Illinois Commerce Commission  
Assessment of Central Illinois Light Company's  
Reliability Report for the 2000 Period

Pursuant to 83 Ill. Adm. Code 411.140

**December 12, 2001**

**Figure 4**  
**Woodpecker Hole & Lightning Damage**  
**Circuit 00-182-002**

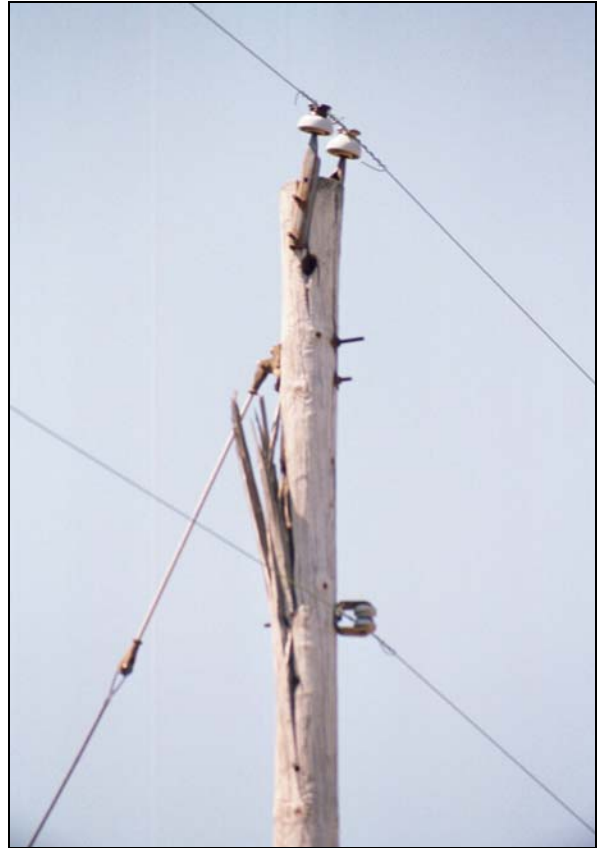
Circuit 00-182-002 is a 12.5 kV circuit fed from CILCO's Stark substation and serving a rural area mostly south of Wyoming (northwest of Peoria). During the field inspection of this circuit in August, 2001, Staff observed that lightning arresters have been added at several locations throughout the circuit, even though that was not mentioned in CILCO's plan to improve the reliability of this circuit. Several tree problems and numerous structural problems were observed on this circuit, as noted in the summary for this circuit, Attachment C. Some of the more common structural problems included split pole tops, shell rotted poles, woodpecker holes in poles, and lightning damaged poles (see Figures 3 and 4). These problems and the large rural exposure are likely reasons for the poor performance of this circuit in 2000 and potential poor performance in the future. The Commission urges CILCO to address the tree and structural problems on this circuit in an effort to prevent it from repeating as a worst performing circuit.

Seventh, CILCO should address the tree and structural problems on circuit 00-182-002 south of Wyoming.

**Figure 11**  
**Woodpecker Holes**  
**Circuit 00-328-124**

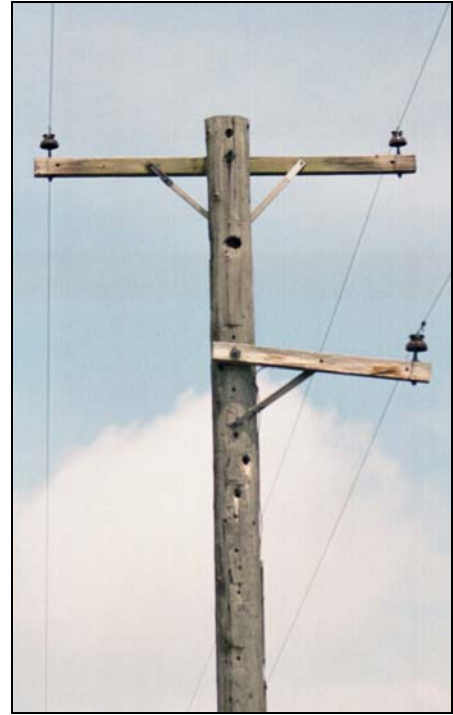
Circuit 00-328-124 is a 12.5 kV circuit serving the towns of Washburn, LaRose, Low Point, and Cazenovia (all northeast of Peoria) and a large rural area surrounding those communities. While not one of the 1% worst performing circuits required to be identified in the annual reliability report, this circuit was CILCO's "next-worst SAIFI circuit" in 2000. The field inspection of this circuit by Staff in July, 2001, revealed an extensive list of potential reliability and safety problems, as noted in the summary for this circuit, Attachment D. Examples of the widespread structural problems noted include 29 split crossarms, 37 other locations with pins fallen through the arms (indicating crossarm rot), and 12 locations with damaged crossarm braces. 36 badly shell rotted poles, 30 split pole tops, and 21 locations with apparent lightning damage to poles were noted. 14 poles with woodpecker damage were noted. Sample photographs of some of these problems are provided in Figures 5 through 13.

While the number of problems noted on this and on other circuits in this report do not represent all of the problems or potential problems that may exist on any of the circuits, it is apparent that CILCO circuit 00-328-124 has more to be concerned about than any of the others inspected by Staff in CILCO's service territory this year. The Commission urges CILCO to perform its own inspection of this circuit and to promptly take appropriate action to fix the problems identified which may have an adverse effect on reliability or public safety.

Eighth, CILCO should perform an inspection of Washburn circuit 00-328-124 and take prompt, appropriate action to fix the structural or other problems that may have an adverse effect on reliability or public safety.

**Figure 14**

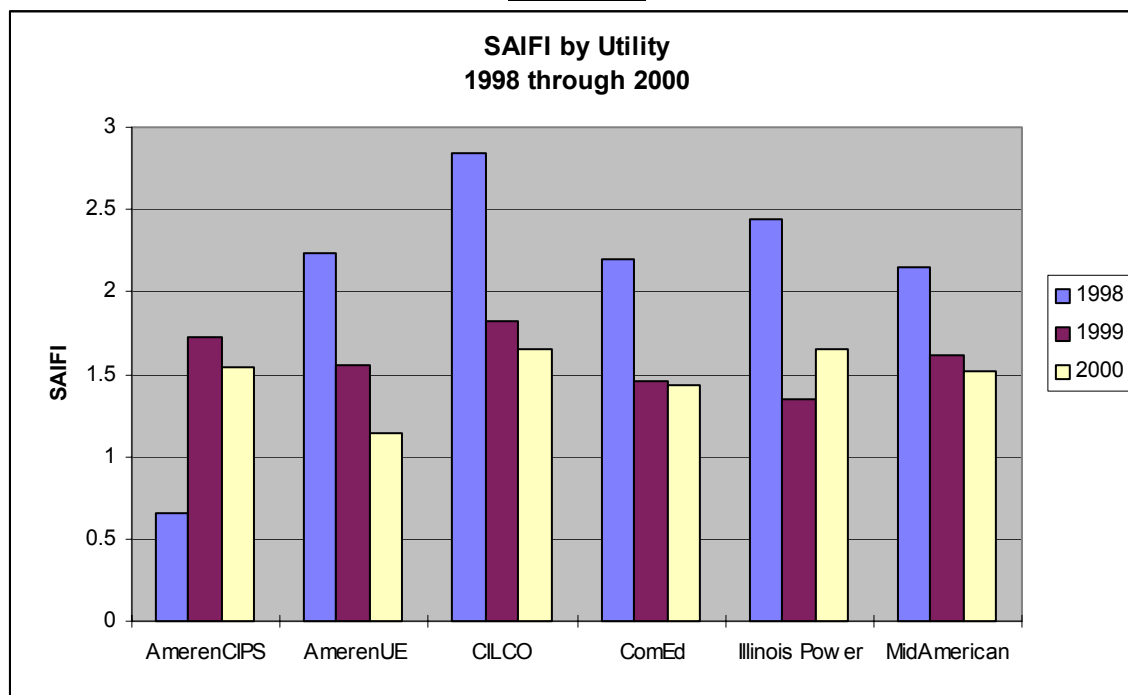
Figure 14 below shows a comparison of SAIFI values reported by the Illinois utilities for years 1998, 1999, and 2000. Storms throughout the state in 1998 increased all utilities' SAIFI numbers. CILCO's reported 2000 reliability performance did not change greatly from 1999. While there is an apparent trend of SAIFI improvement from 1998 through 2000, CILCO still has the highest SAIFI (tied with Illinois Power) compared to the other utilities.

**Figure 15**

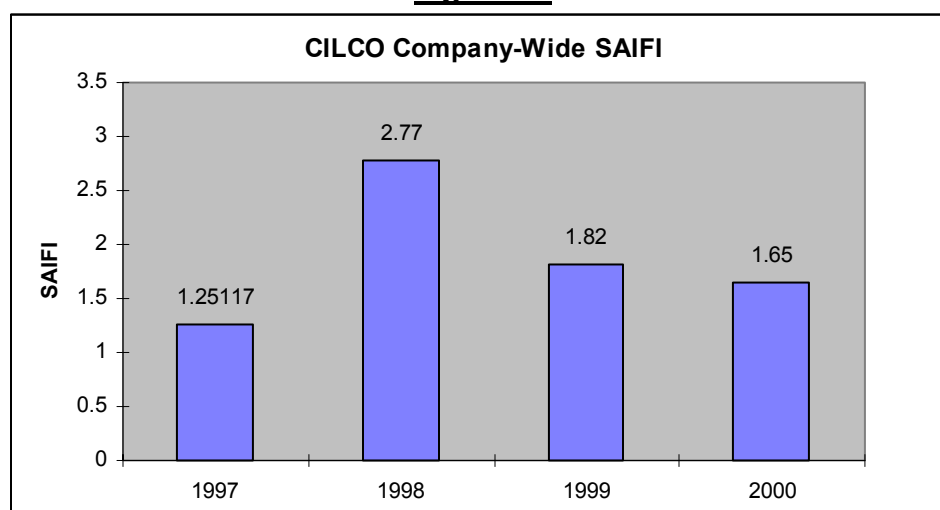
Figure 15 below shows CILCO's SAIFI indices over the past four years. CILCO's reported SAIFI for 2000 indicates a moderate improvement from 1999 in the frequency of interruptions, and the overall trend shows improvement since 1998. Keeping in mind the changes in CILCO's outage reporting system discussed earlier in this report, however, it is unclear to what degree this represents improvement in the actual electric system reliability.

**Figure 16**

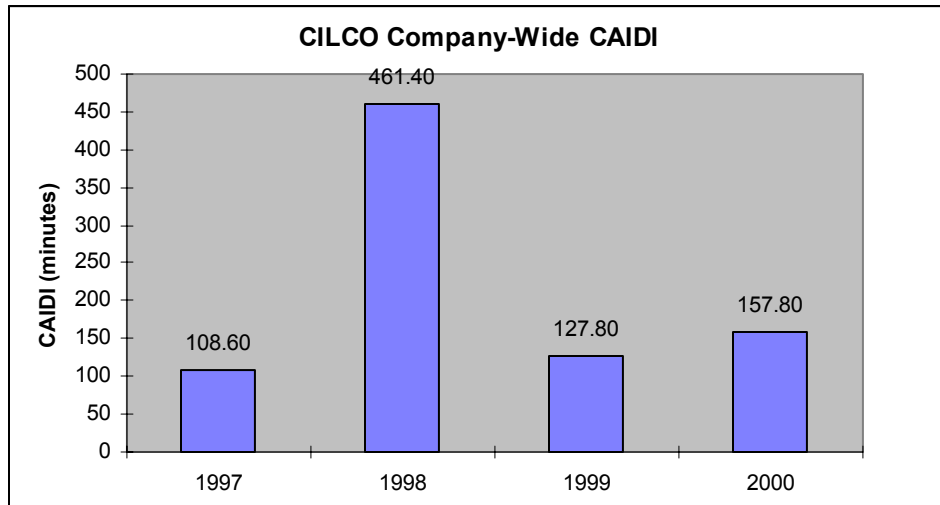
Figure 16 below shows CILCO's system wide CAIDI statistics over the past four years. While there is not a definite, clear trend of these values for CILCO, the 2000 CAIDI index is 23% worse than the one for 1999. Except for 1998, when an unusual number of storms hit all Illinois utilities, the CAIDI trend for CILCO seems to be generally upward.

**Figure 17**

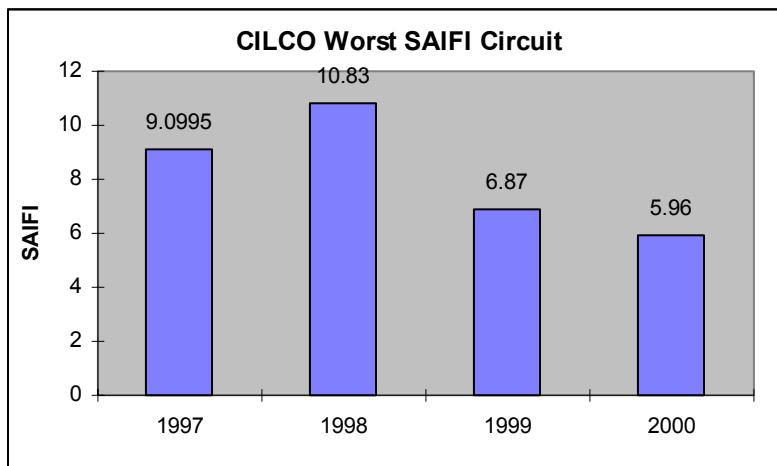
Figure 17 below shows the SAIFI index of CILCO's single worst performing circuit as reported over each of the last four years. For this statistic, the trend is downward (improving) since 1998.

**Figure 18**

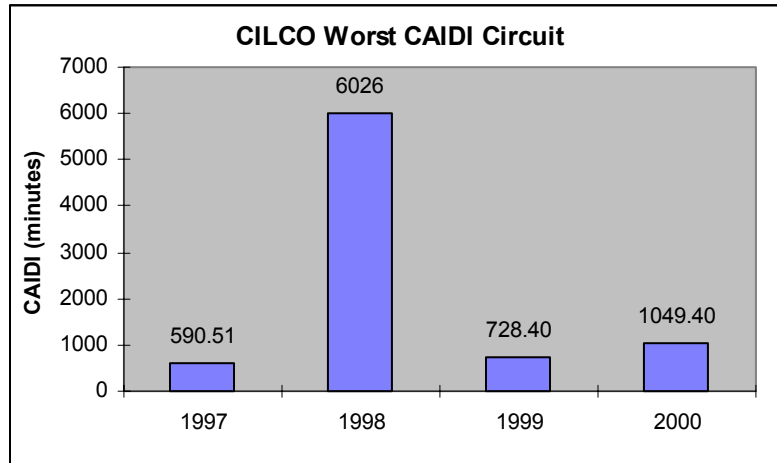
Figure 18 below shows the CAIDI index of CILCO's single worst performing circuit as reported over each of the last four years. Like the company-wide CAIDI index discussed earlier, the trend for CILCO's worst-circuit CAIDI is also generally upward.
